Date:	June 17, 2025
To:	Petra Schuetz
From:	Joe Bessman, PE
Project Reference No.:	1539
Project Name:	Coffin Butte Landfill – VNEQS Response

The purpose of this memorandum is to provide a formal response to comments within the June 10, 2025 memorandum from the Valley Neighbors for Environmental Quality and Safety (VNEQS) related to transportation. These comments were received on the Coffin Butte Landfill conditional use application for expansion south of Coffin Butte Road as part of LU-24-027. Transportation comments within the letter are summarized below and are followed by our response.

Figure 1. Total tonnage by location (includes daily top cover)

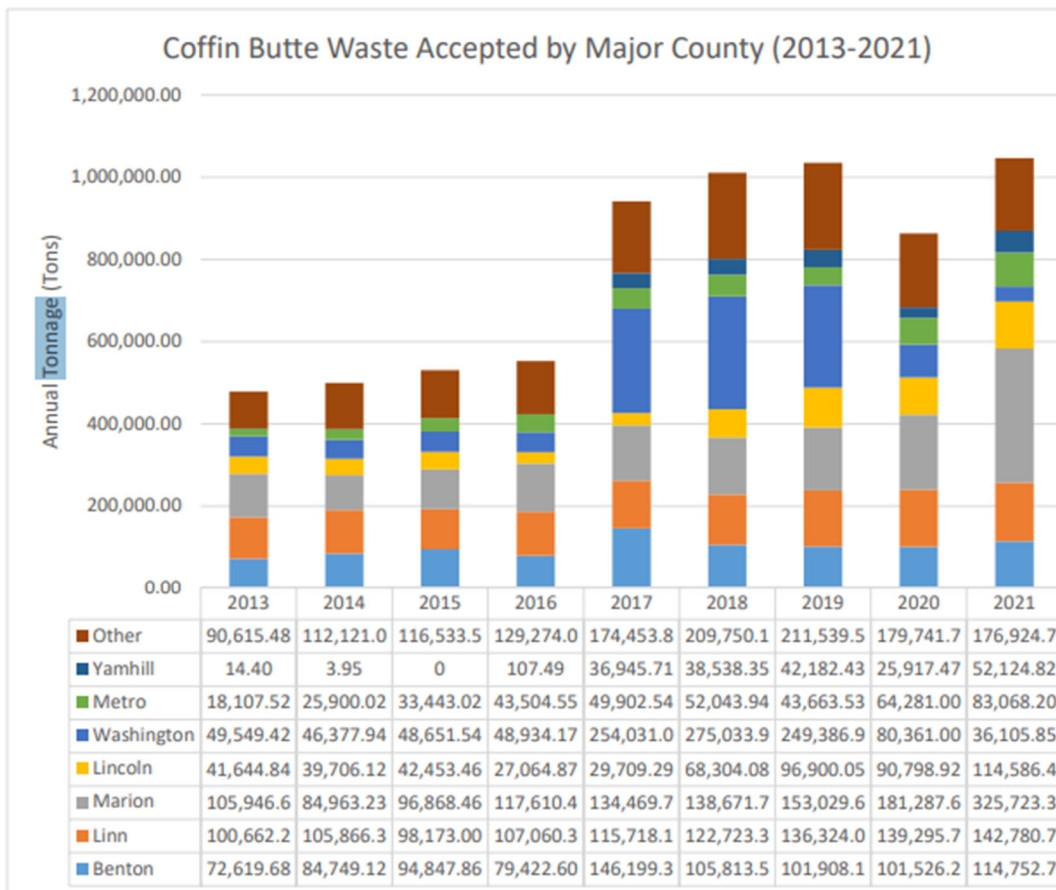
Comment 1: The applicant generally assumes that the level of future impacts will be identical to current impacts, when the actual impacts could be double. The annual limit of 1.1 million cubic yards could increase to 1.5 million in years 1-4, and to 1.86 million in years 5-6.

Response: The landfill quantities cited are entirely speculative; within the footnotes of the opposition comments on page 5 it appears that the opponents are mixing changes in total landfill area (acres) with traffic, but these metrics do not correlate. As stated, the transportation study assumed that landfill tonnage would generally follow area population growth, which is projected for the Linn-Benton Counties to remain at about 1 percent annual growth (or less), as documented within the original Transportation Impact Analysis as cited within adopted long-range plans. The traffic study acknowledges that waste levels can vary on an annual basis due to external factors, so in lieu of assessing growth through the approximately seven-year lifespan of the expansion site, accounting for minor trips to the current site, or movement of transfer vehicles between sites, we provided an analysis showing the operational impact of a 50% increase in current (measured and observed) landfill traffic volumes that was reassigned to the system based on the proposed configuration of the scales.

Correlating a 50% trip increase to a tonnage change does not provide a direct conversion for this site; the presence of transfer stations that “intercept” landfill trips results in fewer trips with larger trucks (heavier loads and higher per-vehicle tonnage) from longer distances. Some transfer stations also include solid waste compactors, which can increase tonnage within an equivalent volume. Accordingly, as the site is already a regional landfill that provides trash services for adjacent counties, any increase in tonnage would necessarily occur from longer-distance transport. A 50 percent increase in site trips (which would predominantly consist of larger transfer trucks rather than personal vehicles, dump trailers, or even garbage trucks) equates to more than double the current tonnage and would still provide a very conservative analysis. There are no current plans by Republic Services to increase its operations at the site, but operational fluctuations have occurred historically, and the site is designed to accommodate these levels.

The Benton County Talks Trash (“BCTT Report”) Solid Waste Process Workgroup Report, dated April 2023¹, provides historical data historical tonnage information broken out by contributing source. Figure 1 illustrates this trend for the Coffin Butte Landfill. This graphic and accompanying text describe the tonnage increase between 2016 and 2017 as primarily attributable to increased refuse from Washington County in an effort to extend the lifespan of the Riverbend regional landfill. This tonnage was dispersed to other landfills in 2020, resulting in the Coffin Butte tonnage reduction, with this reduction possibly also attributed to the pandemic. The 2021 tonnage increased due to area fires (note that fire and flood intake are exempt from the tonnage cap). Other factors noted by the subcommittee that could influence annual waste tonnage included recession/economic factors, societal changes in waste generation, disposal alternatives, global health issues, environmental legislation changes, and natural disasters.

The BCTT report also provided information on landfill lifespan. Consistent with the traffic study, this forecast was also premised on a “steady annual tonnage intake of between 1 million and 1.1 million tons for the duration of the landfill’s projected remaining site life.” (BCTT, pp 618). Accordingly, as the transportation analysis was premised on current conditions plus 50% traffic increases into the landfill (approximately equivalent to doubling the current waste tonnage using transfer stations). This scenario is more conservative than the status-quo assumptions for the Coffin Butte landfill within the BCTT report. Accordingly, no changes to the report are needed to address this comment.
